Product Change Notice (PCN)

Subject: Change Shipping Media on Select Package

Publication Date: 12/8/2020

Tray Drawing QFN 3mm x 3mm

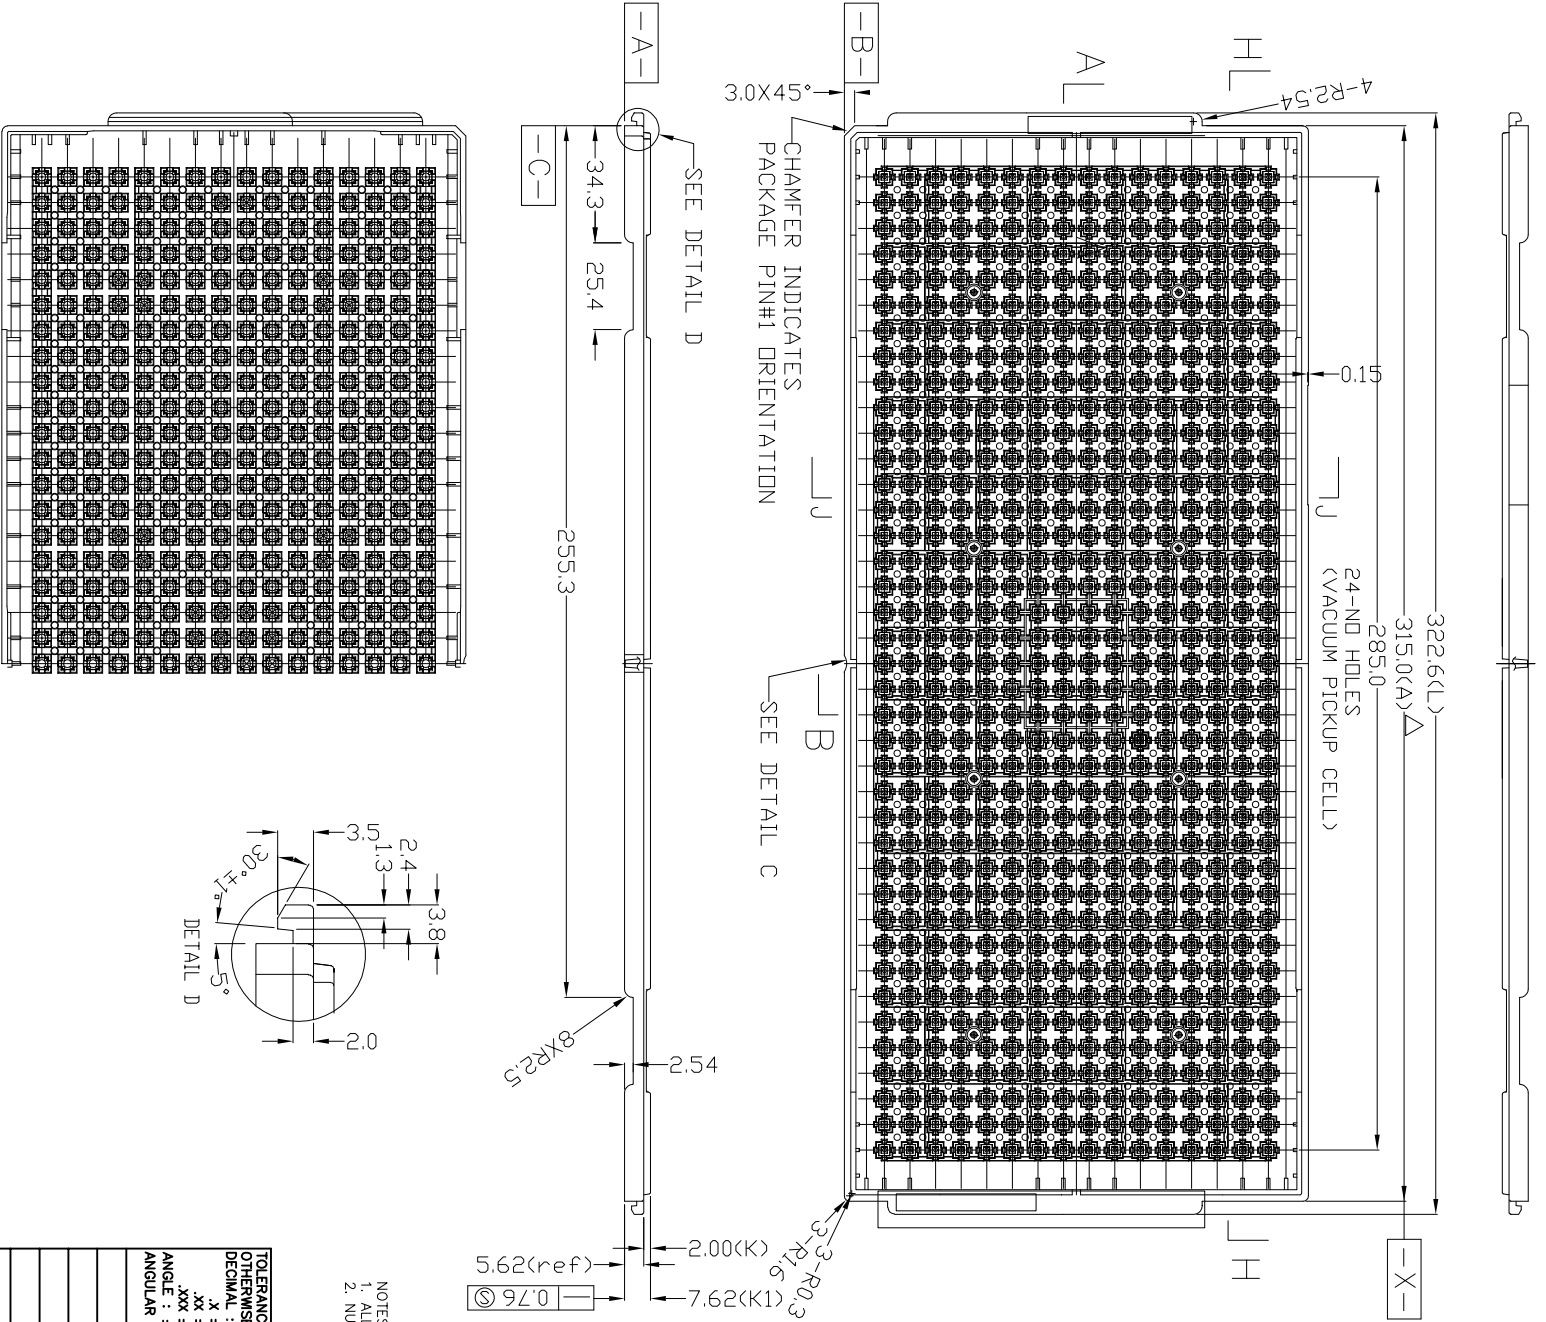
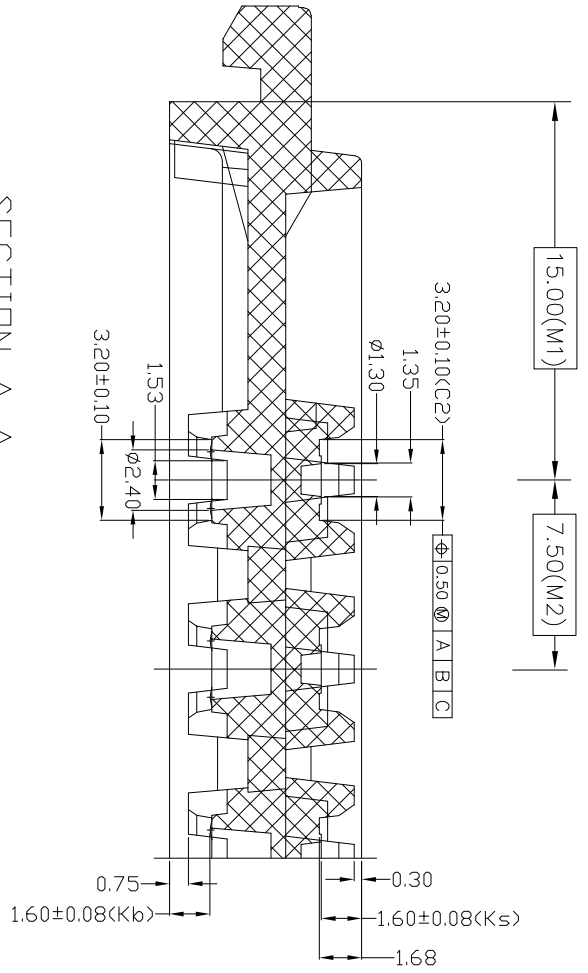
Renesas is converting shipping media from Tube to Tray on package QFN 3mm x 3mm and QFN 4mm x 4mm. The current shipping media in Reel remains unchanged. Industrial standard JEDEC shipping trays will be introduced. Refer Appendix B for tray drawings.

Affected Packages	Shipping Tray Supplier	Shipping Tray Part#
QFN 3mm x 3mm (NLG16, NDG20)	ePAK	eN QFN0303 1.2 1639 13
QFN 4mm x 4mm (NLG20, NLG24, NDG28)	ePAK	eN QFN0404 1.1 1435 13
